ADDENDUM NO. 3

May 3, 2022

YOST ELEMENTARY SCHOOL ADDITIONS AND RENOVATIONS
Chesterton, IN 46304

Addendum Three (AD.03) to the drawings and specifications prepared by Gibraltar Design for **New Newton Yost Elementary School** for Duneland School Corporation, Chesterton, Indiana.

SHEET C-02

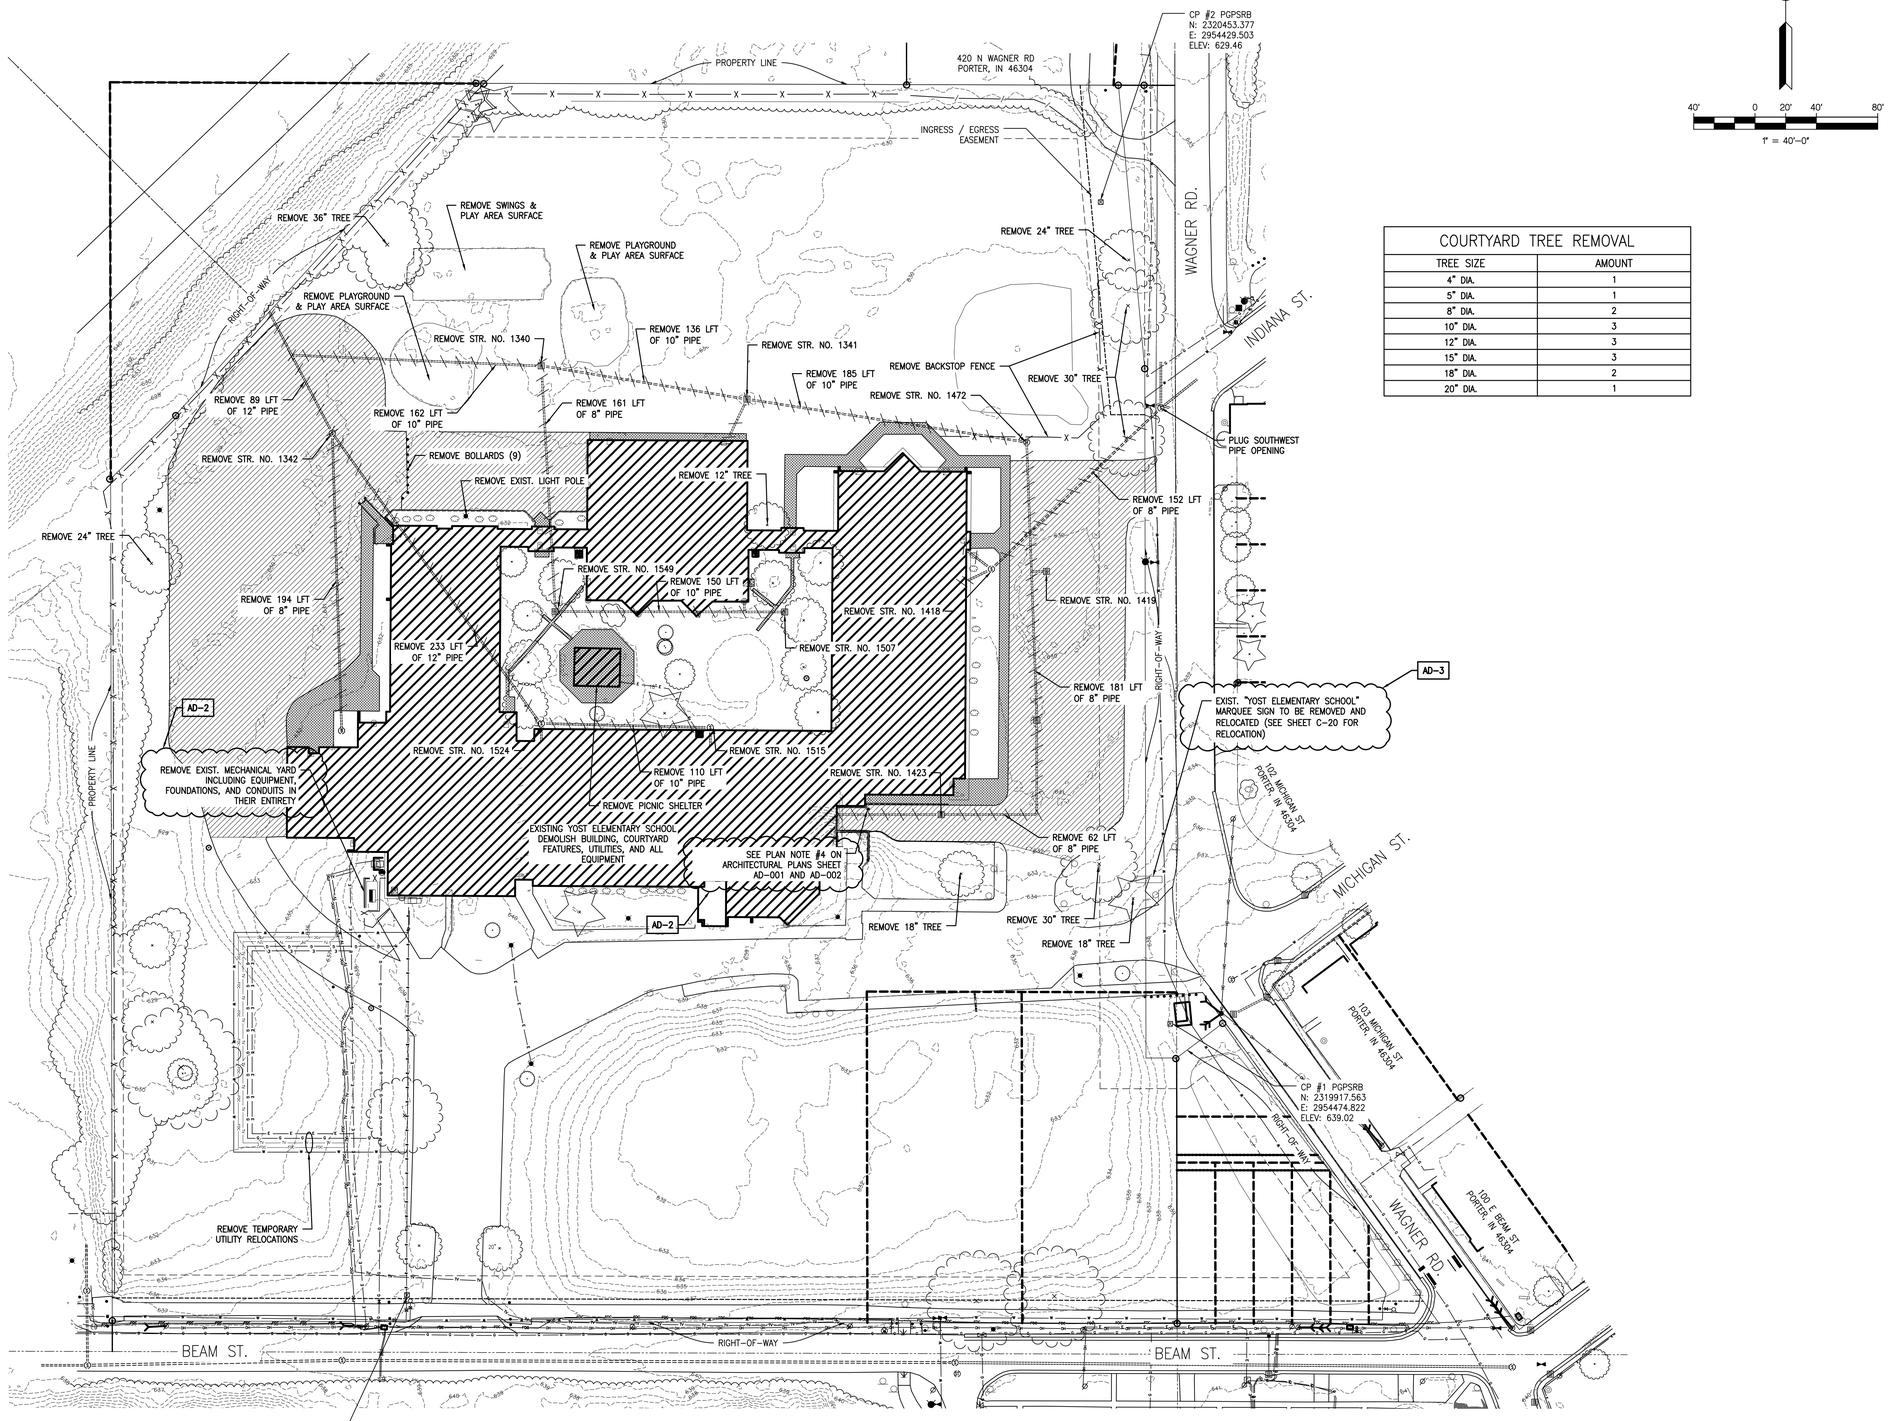
24. Sheet C-02

SHEET
C-03

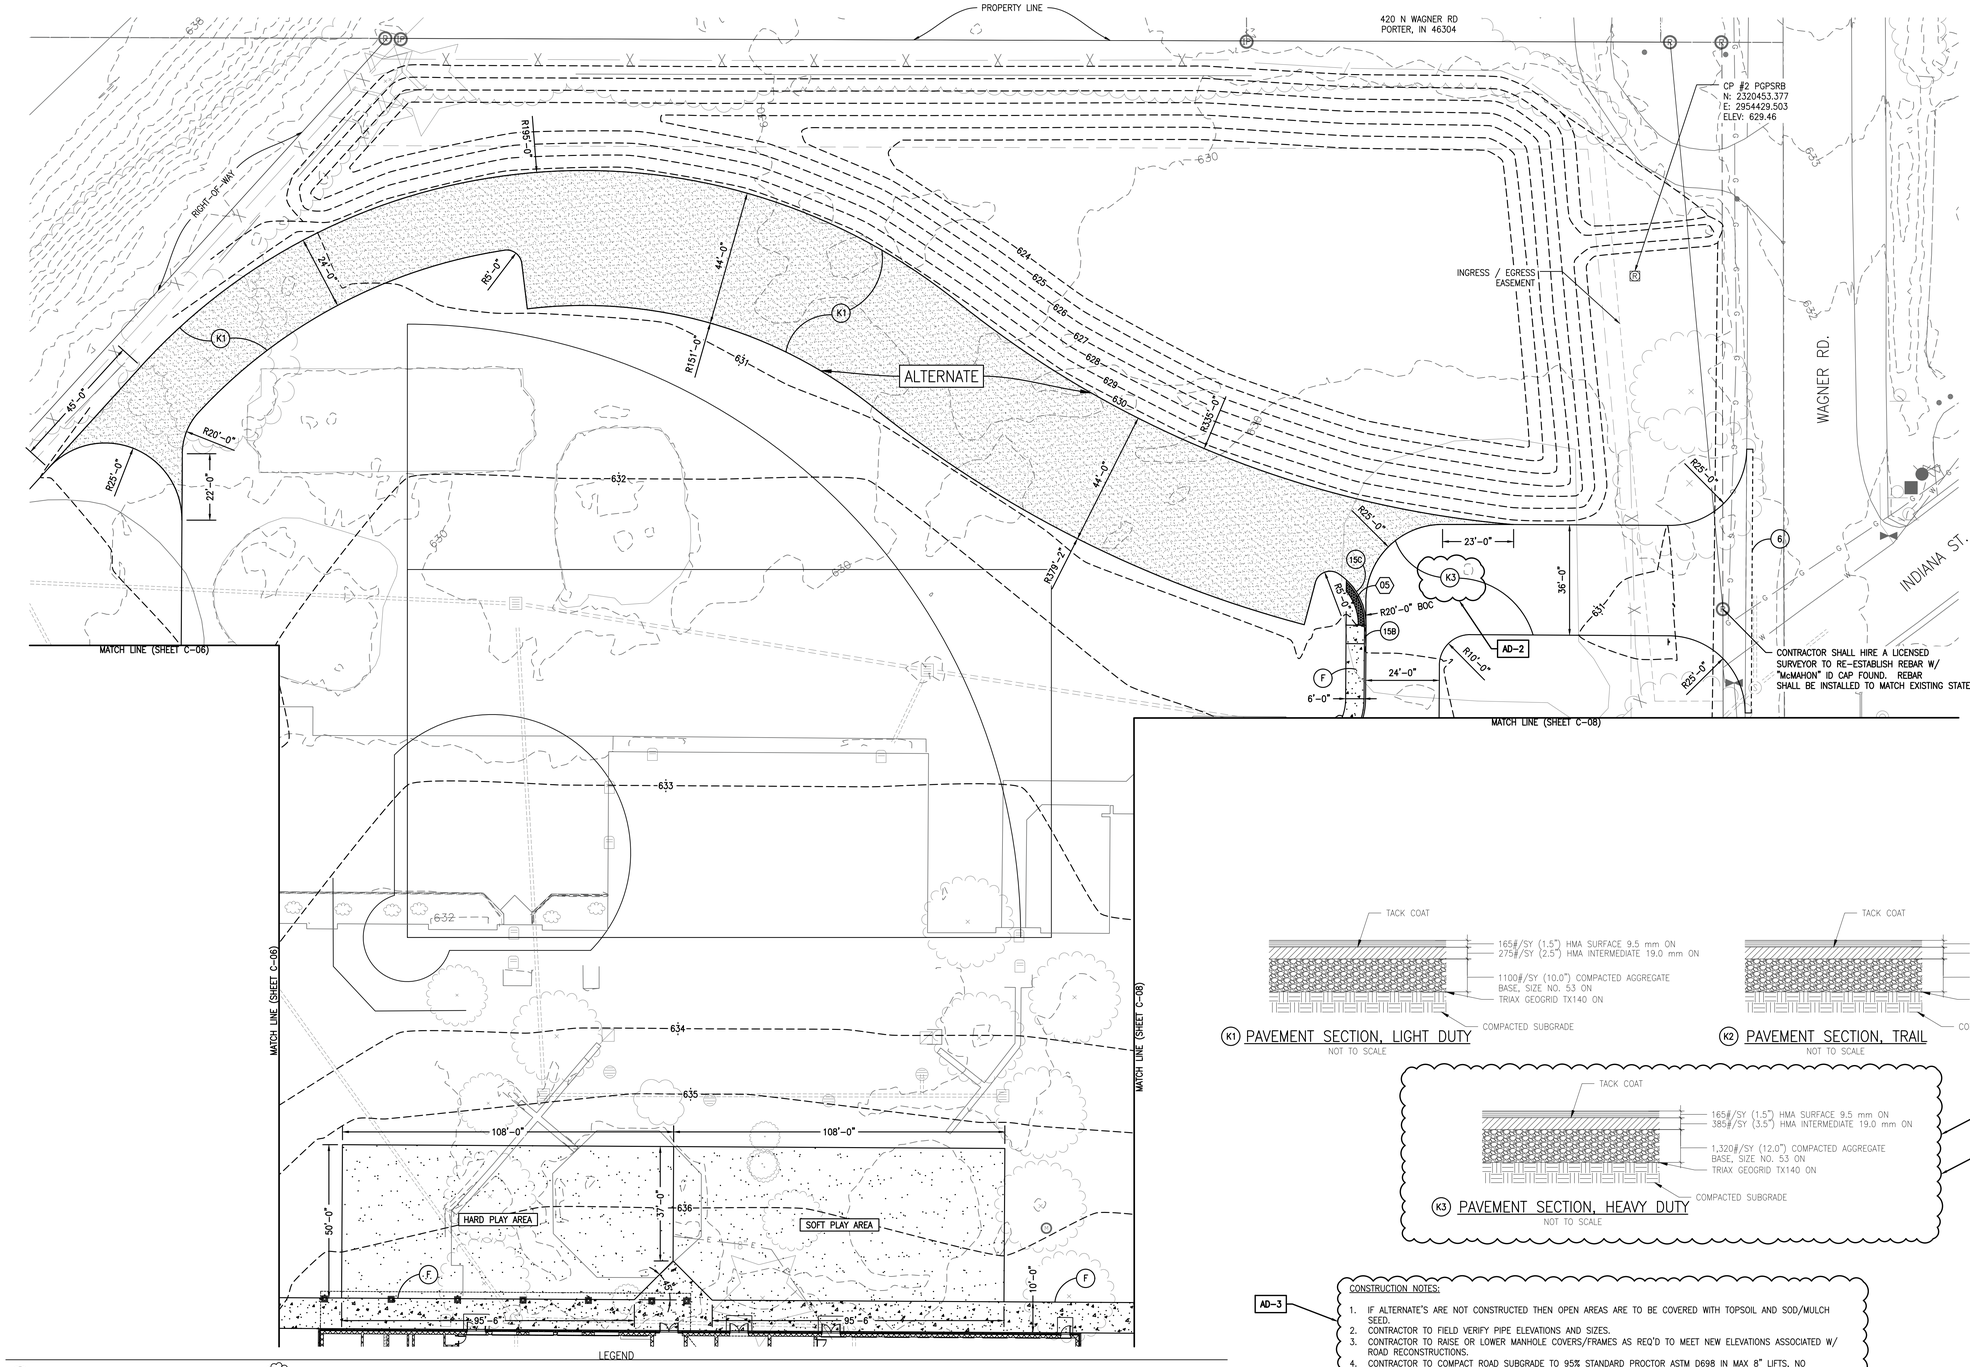
25. Sheet C-03

SHEET C-07

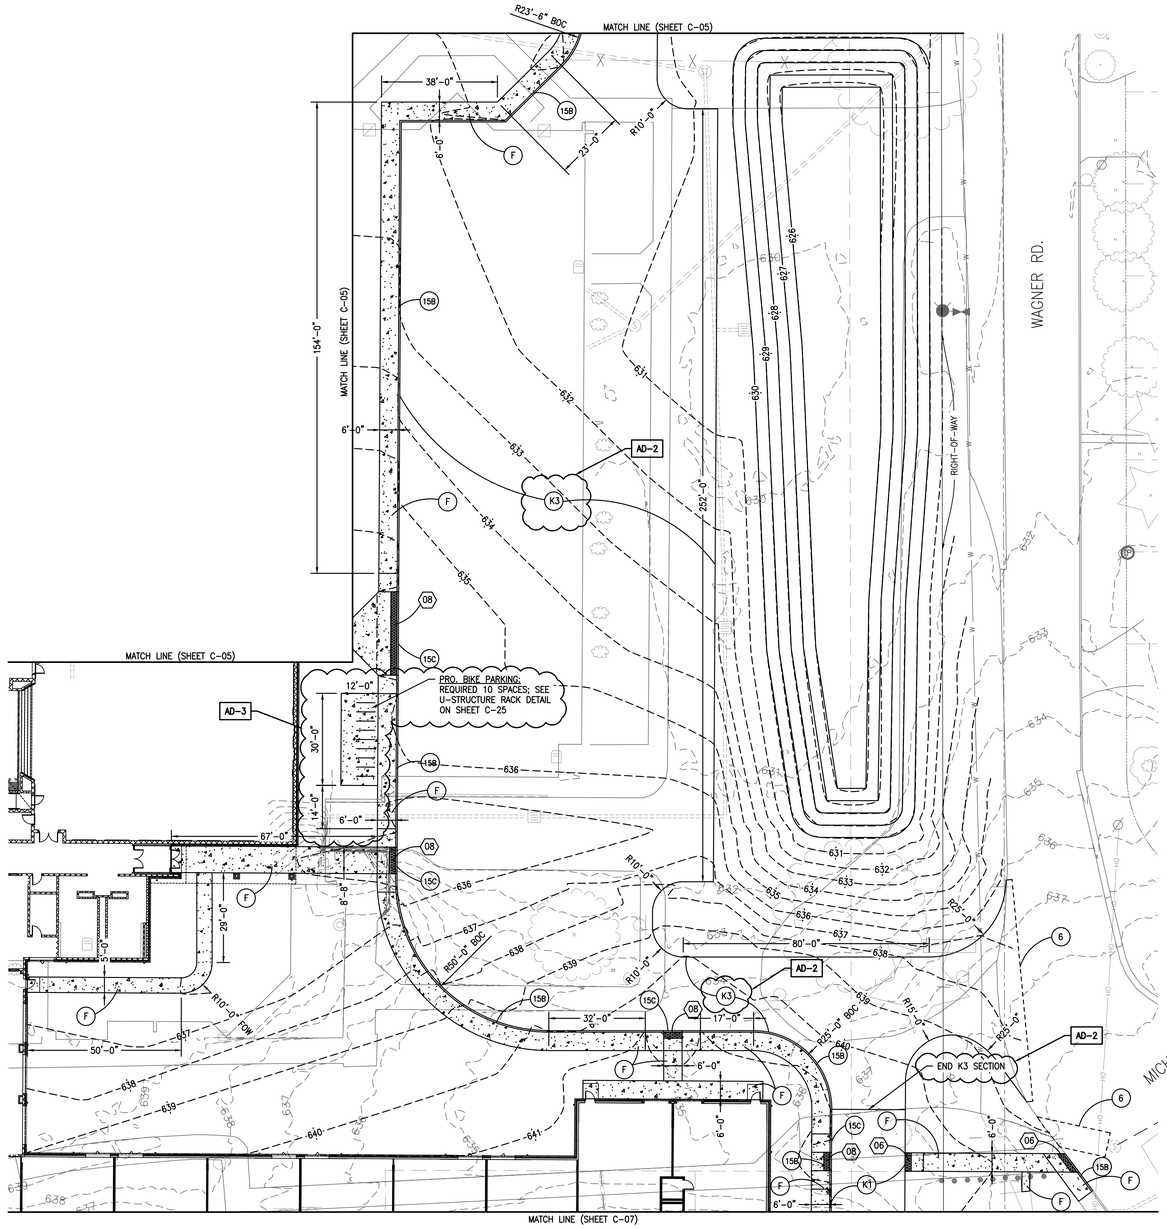
28. Sheet C-07

SHEET C-08

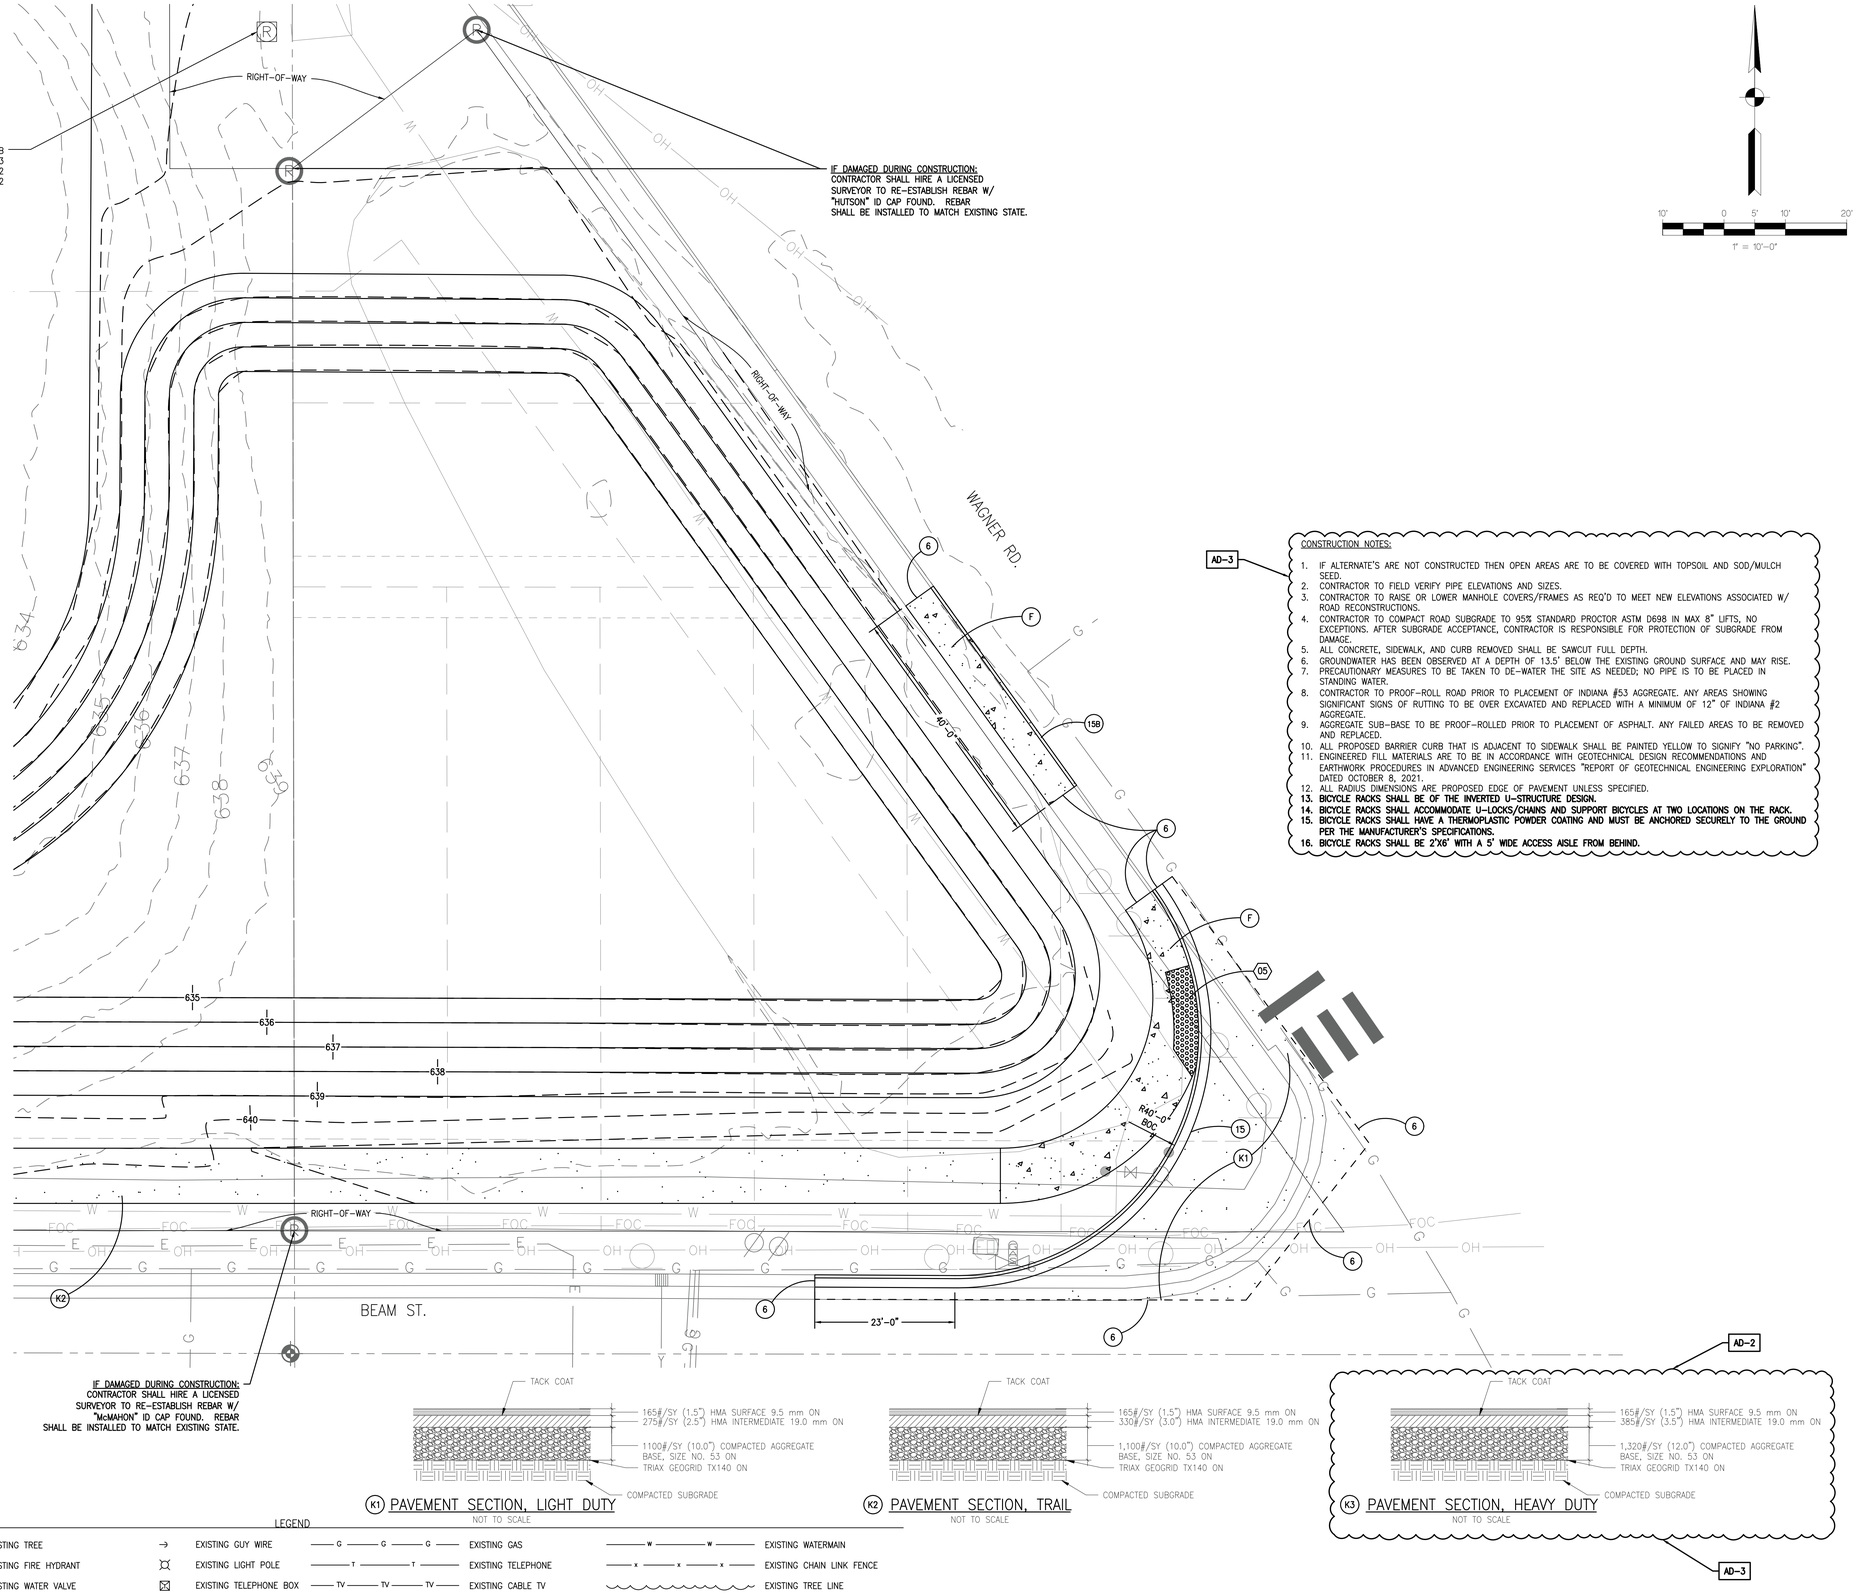
29. Sheet C-08
